FRIGG FIELD | Dwgr. no. FF 83 00 00 0021 | Rev. 1 | Sheet 2/2

ELF NORGE
FRIGG FIELD E17 JOB 1.40.G2-DP2 DECK MODULE EQUIPMENT

ACCESS & PLATFORMS GENERAL ARRANGEMENT
SHEET 2 OF 2

DRAWING No. EF7478.00.151 B

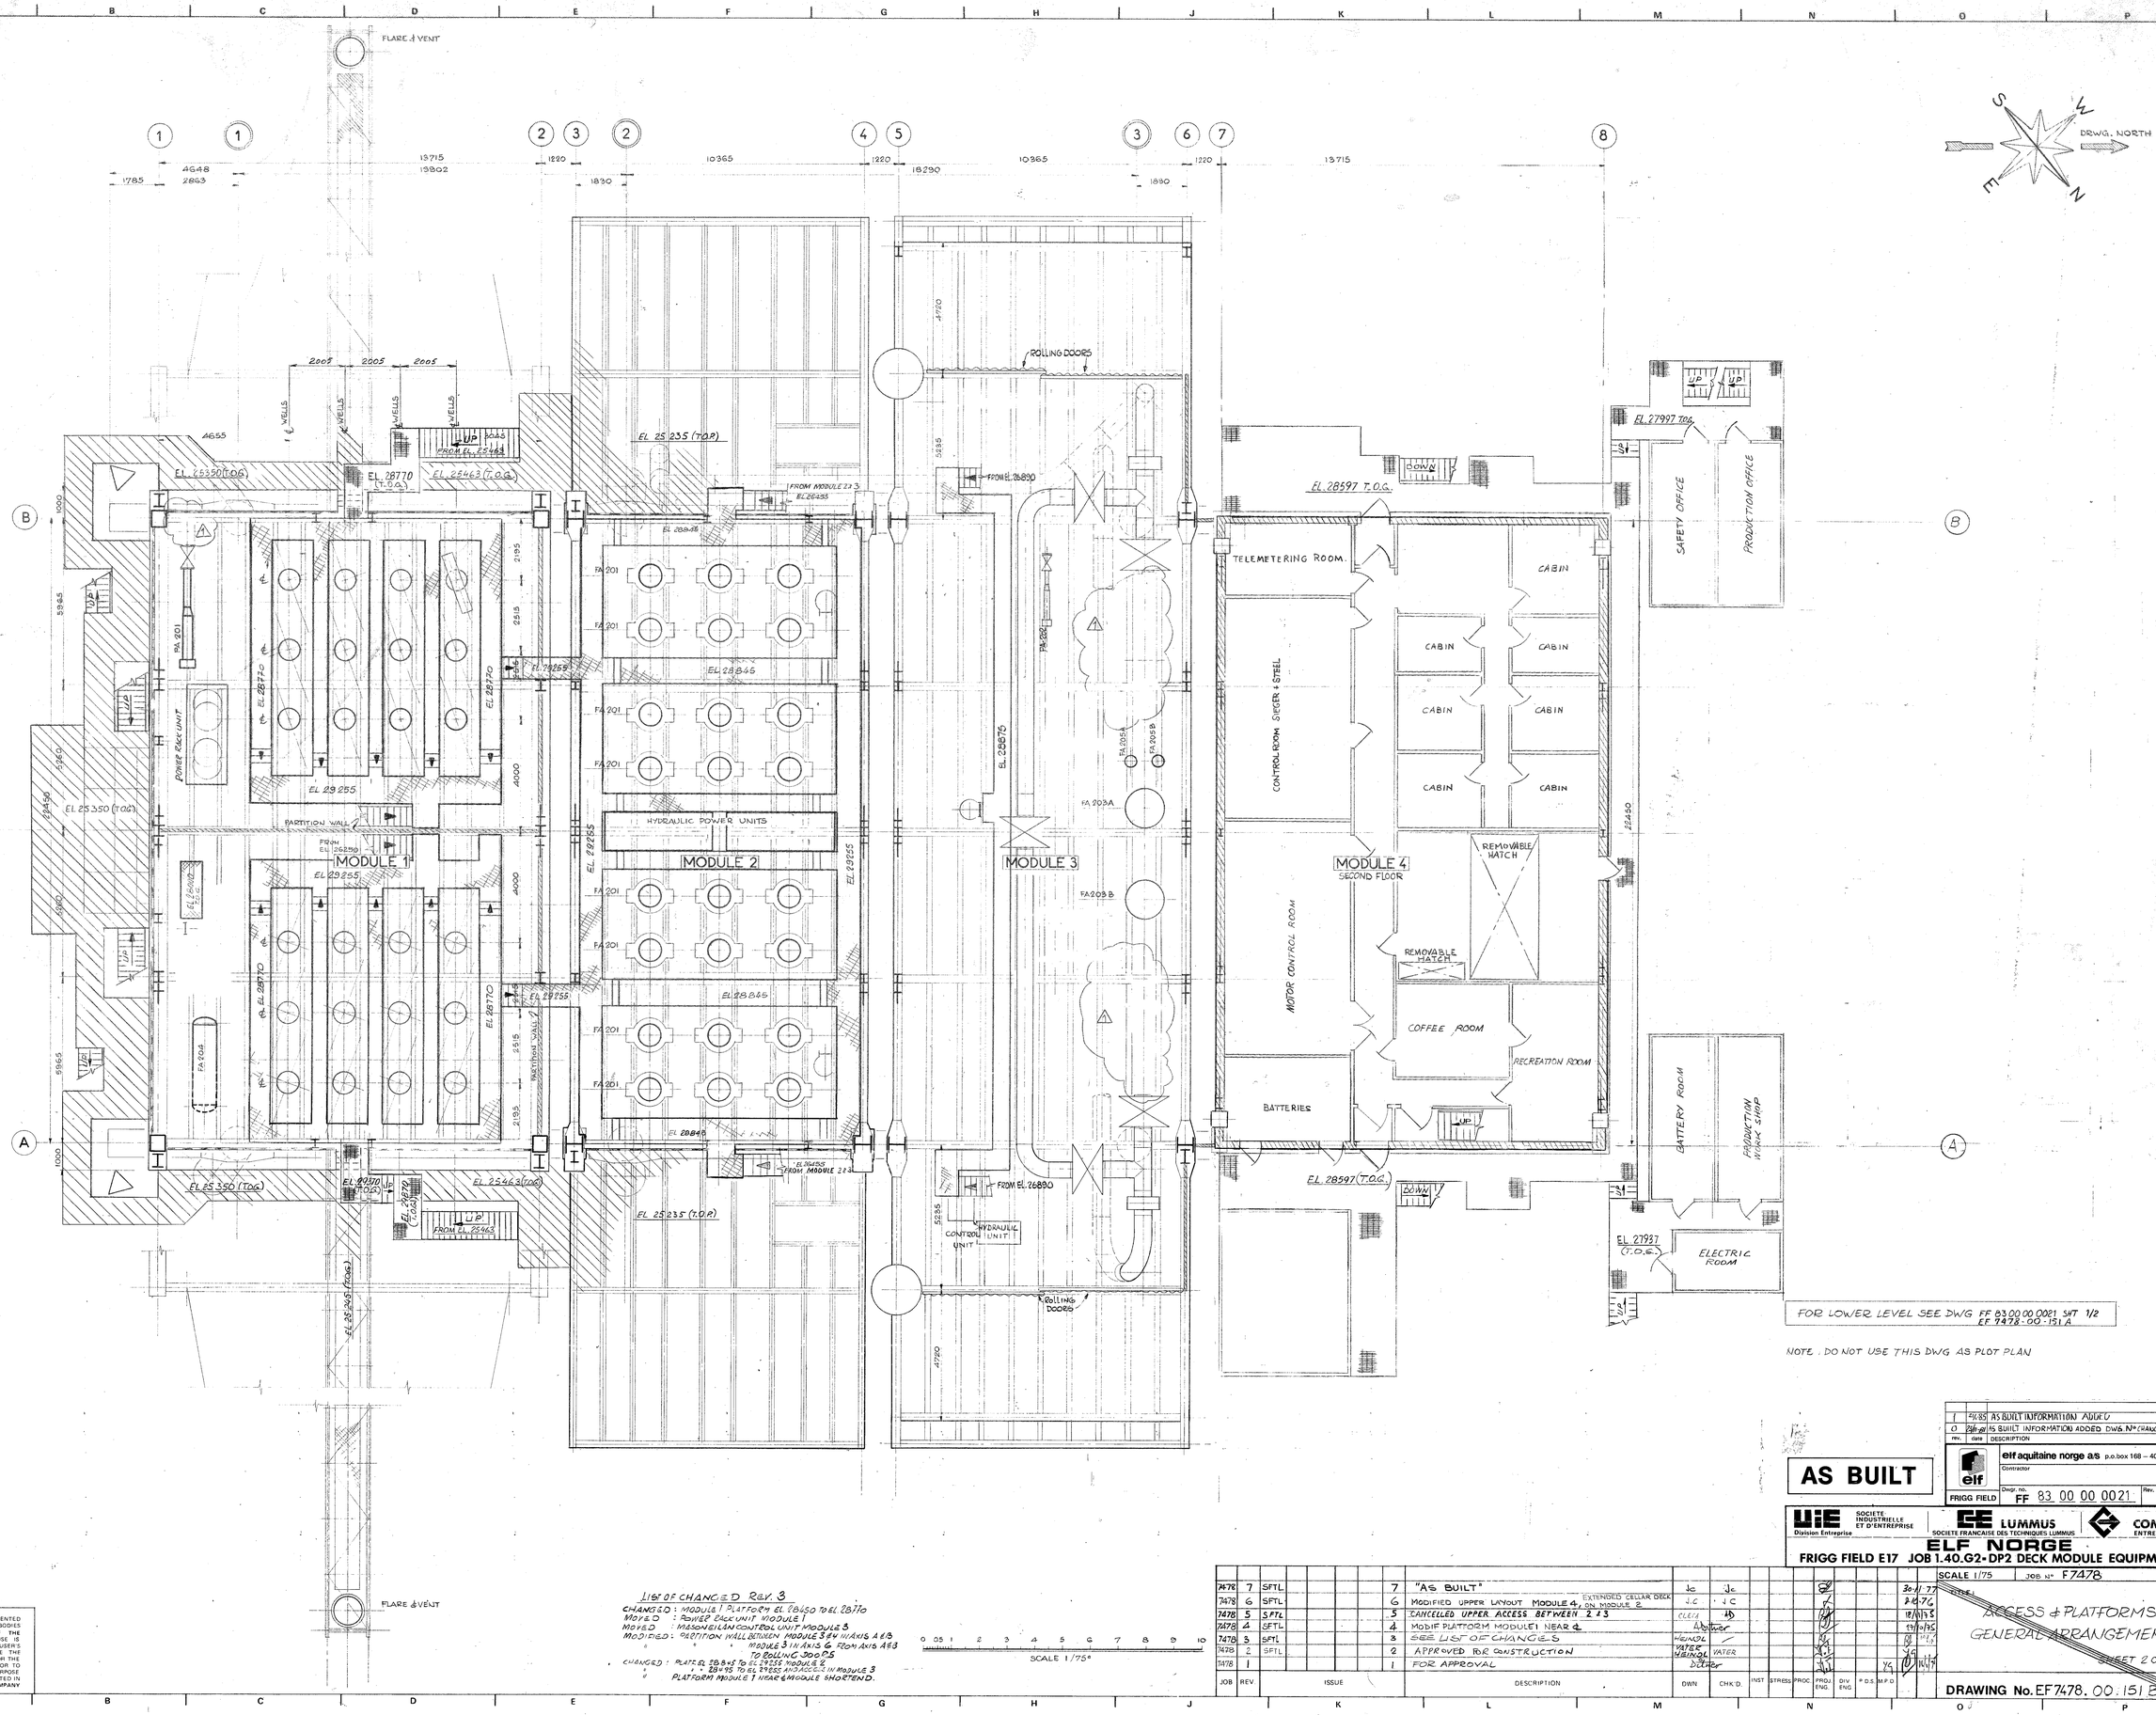
CHANGED : MODULE 1 PLATFORM EL 28450 TO EL 28770
MOVED : POWER PACK UNIT MODULE 1
MOVED : MASONEILAN CONTROL UNIT MODULE 3
MODIFIED : PARTITION WALL BETWEEN MODULE 3 & 4 IN AXIS 1 & 3
" " " MODULE 3 IN AXIS 6 FROM AXIS A TO B
" " " ROLLING DOORS
CHANGED : PLATF. EL 28845 TO EL 29255 MODULE 2
" " 28495 TO EL 29255 AND ACCESS IN MODULE 3
PLATFORM MODULE 1 NEAR & MODULE SHORTEND.
